ACRS THERMAL HYDRAULIC PHENOMENA SUBCOMMITTEE MEETING MINUTES
 REVIEW OF THE NRC-RES ROSA-V TEST PROGRAM
 OCTOBER 28, 1993
 BETHESDA, MARYLAND

The purpose of the meeting was to review selected aspects of the NRC Office of Nuclear Regulatory Research's (RES's) ROSA-V confirmatory test program being developed in support of the Westinghouse (W) AP600 passive plant design certification effort. Specifically, the ACRS was asked by the Commission to review the following topics relative to the ROSA-V Program: the test matrix and facility design modifications and additions, including instrumentation and controls.

Figure 1. Elevation Drawing of Proposed Integral Facility for SBWR

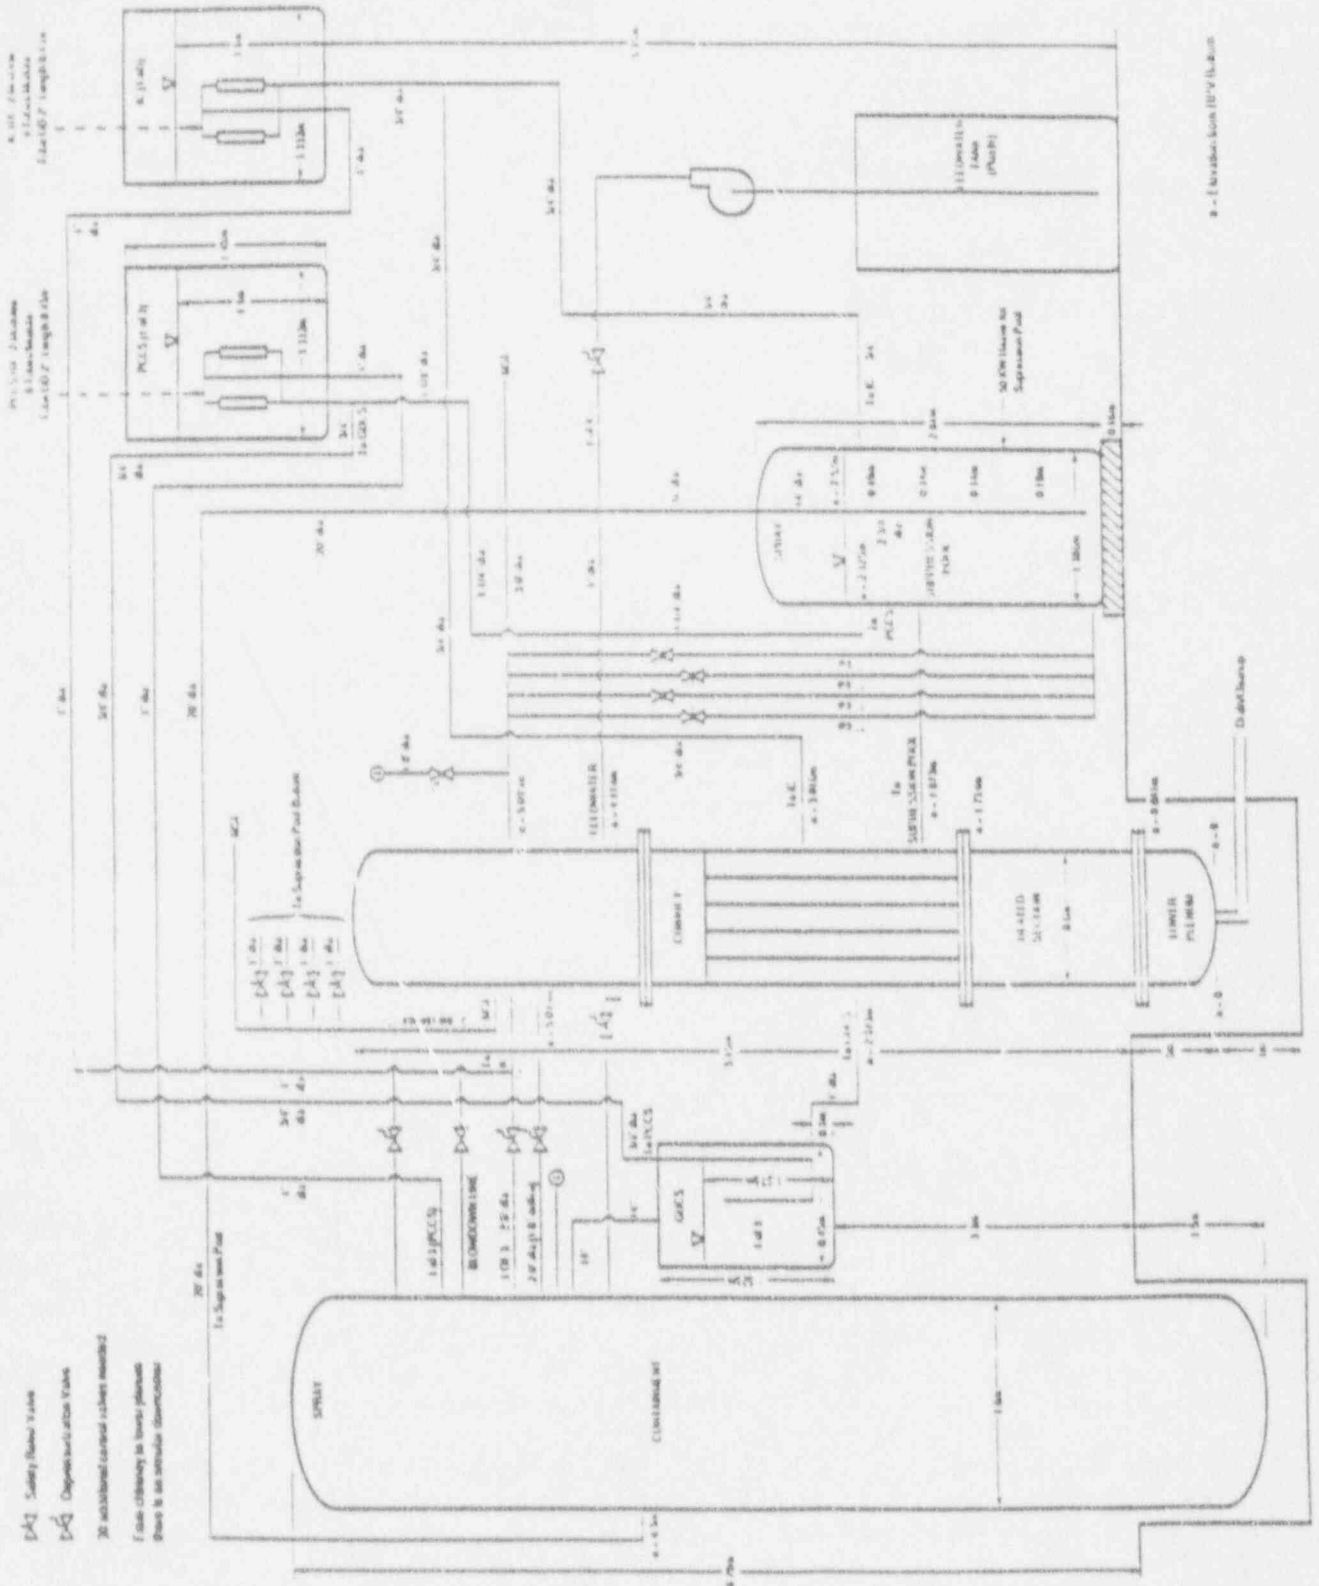
Dr. Dhir asked if a facility scaling study has been conducted. Dr. Han said that a report on the preliminary scaling analysis should be available in December 1993. He said that he will provide the Subcommittee with a copy of this report.

7. Dr. Han said he would provide the Subcommittee with a copy of the report on the preliminary scaling study conducted in support of the RES SBWR confirmatory test facility to be constructed at Purdue University.
